PROPOSED TECHNICAL SPECIFICATION CHANGE NO. 31

SUPPLEMENT TO ATTACHMENT 1

Evaluation of proposed changes to Unit 1 Technical Specifications are listed below.

Figure 6.2-1 Offsite Organization for Facility Management and Technical Support

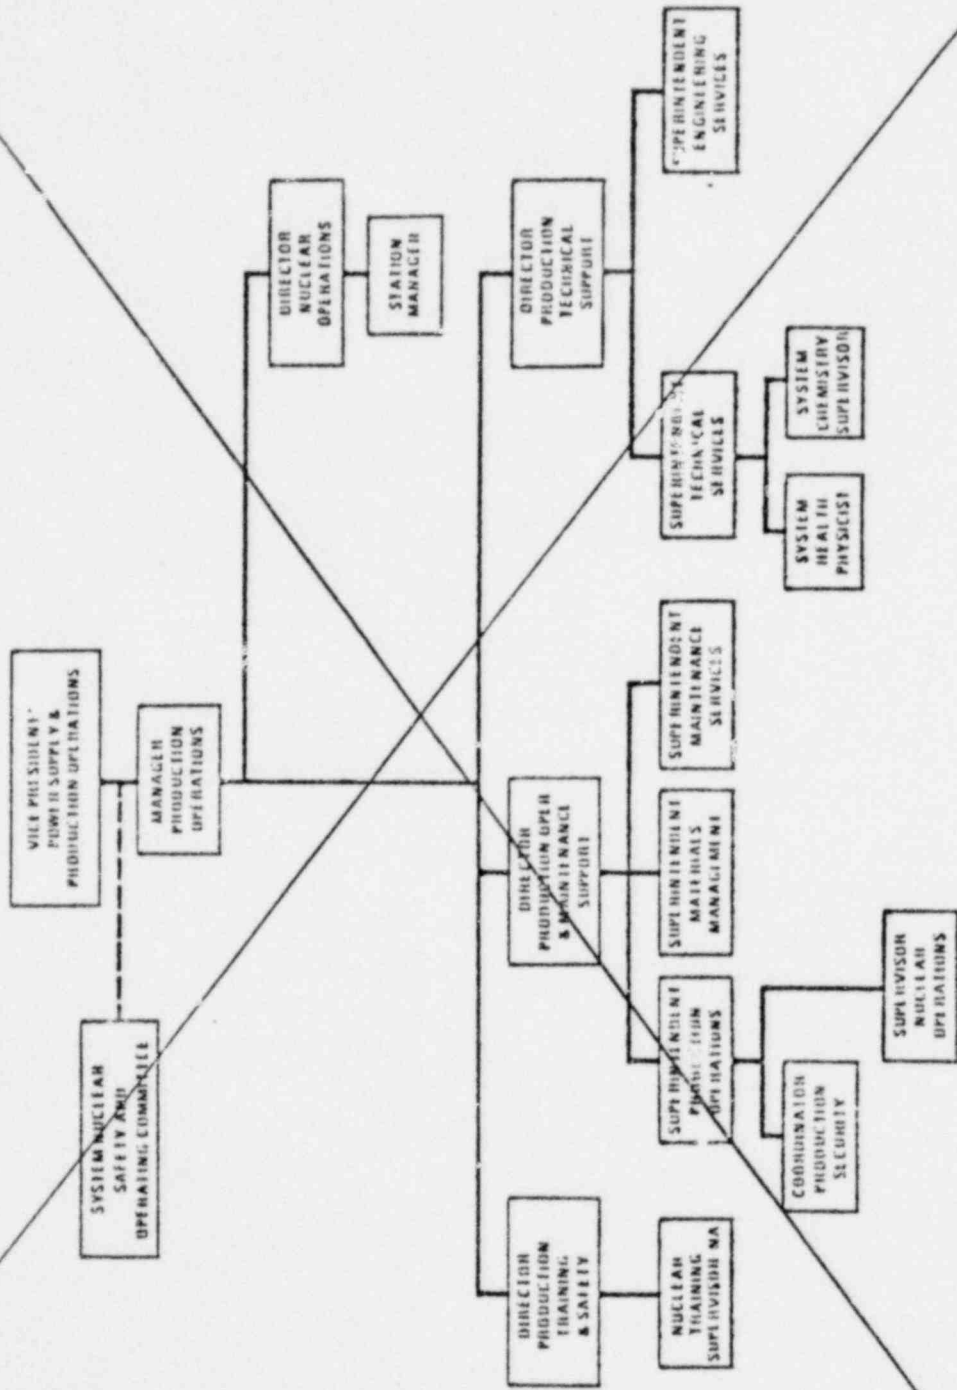
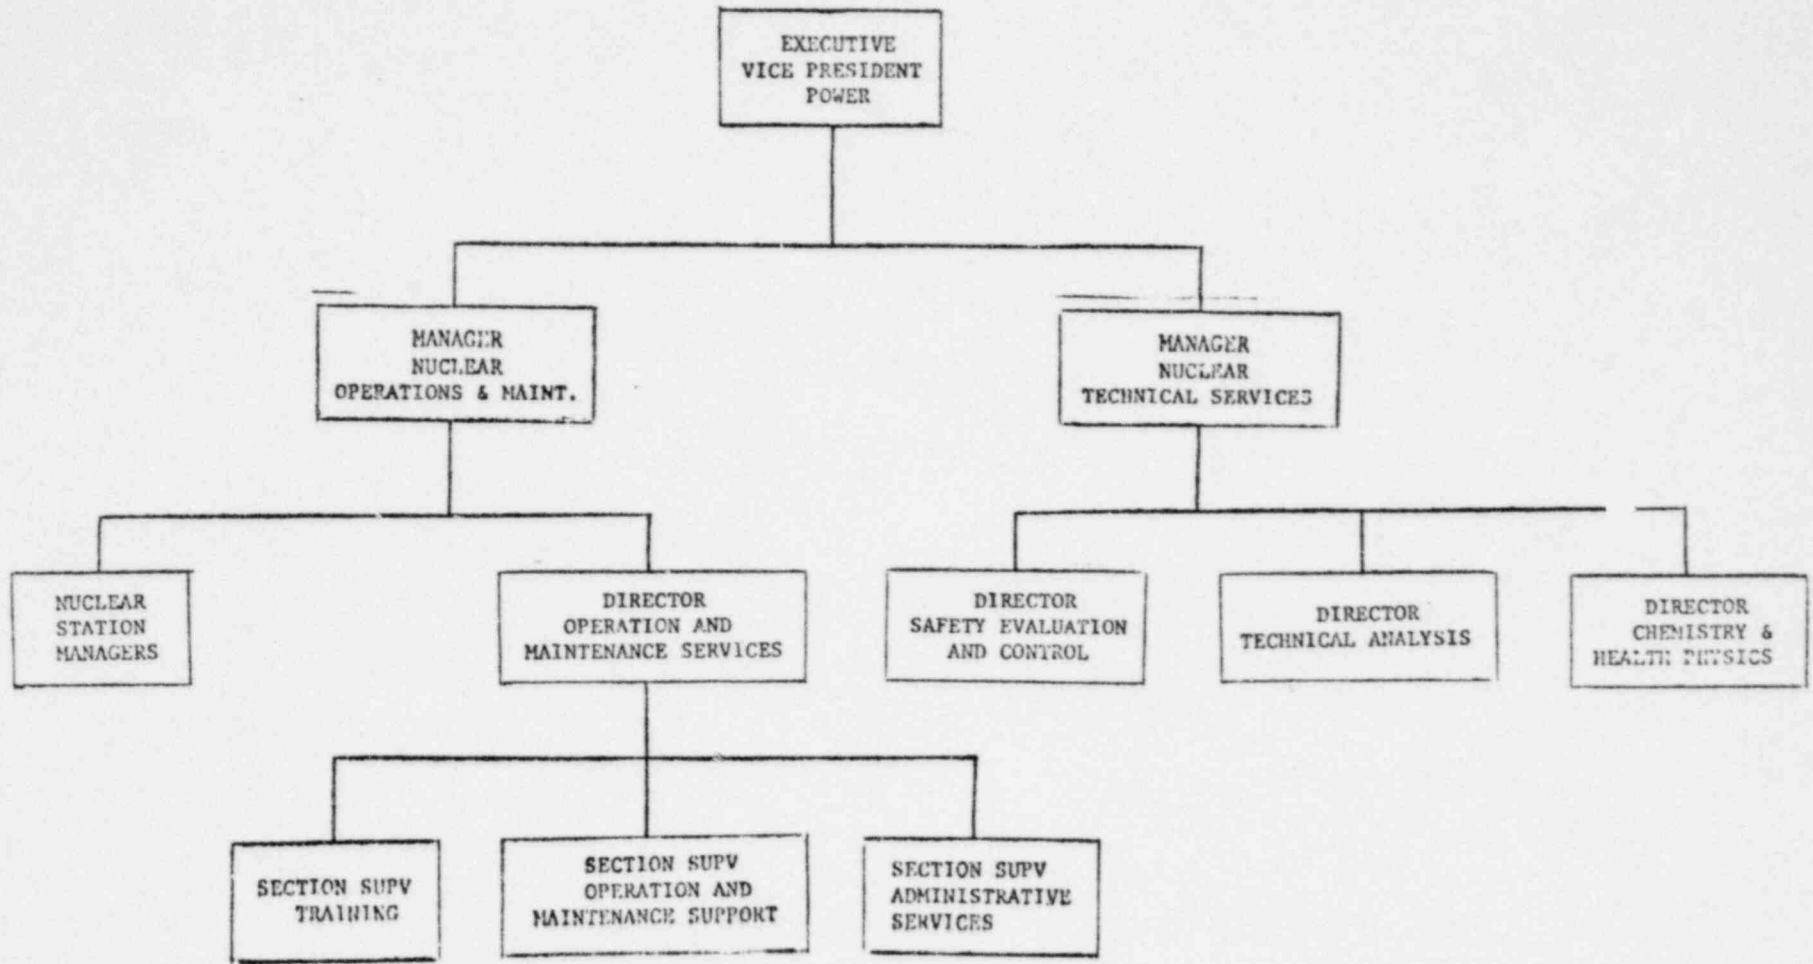
Page 6-2	Revise Figure 6.2-1 to reflect new offsite organization for facility management and technical support.
Page 6-3	Revise Figure 6.2-2 to reflect new North Anna facility organization.
Page 6-3a	Add Figure 6.2-3 to reflect revised organization of Power Operations.
Page 6-4*	Change Unit 1 Table to same format as Unit 2 Table.
Page 6-4a*	Add Unit 1 Table similar to Unit 2 Table format.
Page 6-5	Revise responsibility for facility staff training programs and position deletion.
Page 6-7	Change position titles.
Page 6-8	Revise the composition of the SyNSOC and correct typographical error.
Page 6-11	Revise the reporting function of the SyNSOC and change position titles.
Page 6-12	Change position titles.

Figure 5.2-1
 ORGANIZATION CHART
 ENVIRONMENTAL TECH SPEC IMPLEMENTATION

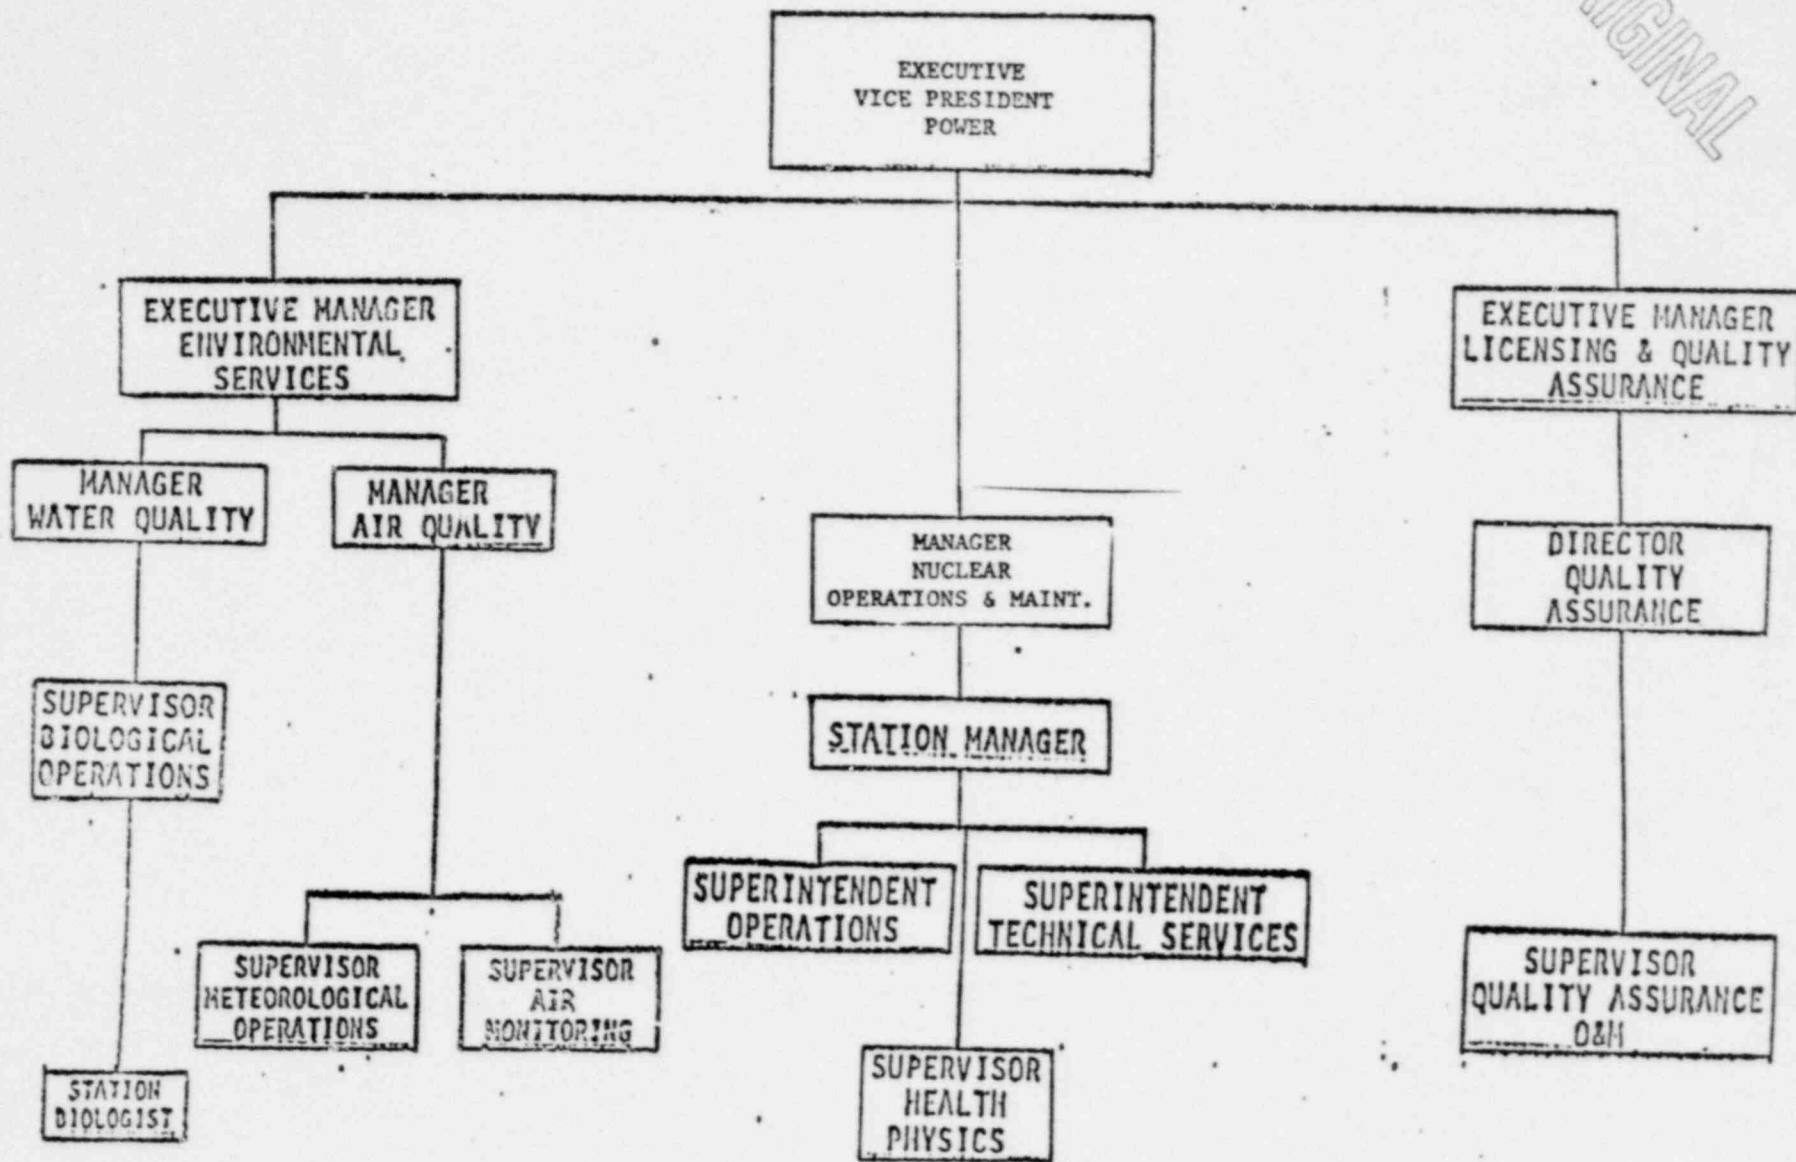
Page 5-1	Change position titles.
Page 5-2	Revise Figure 5.2-1 to reflect new organization chart for environmental tech spec implementation.
Page 5-5	Change position titles and revise the reporting authority of SyNSOC on environmental matters.
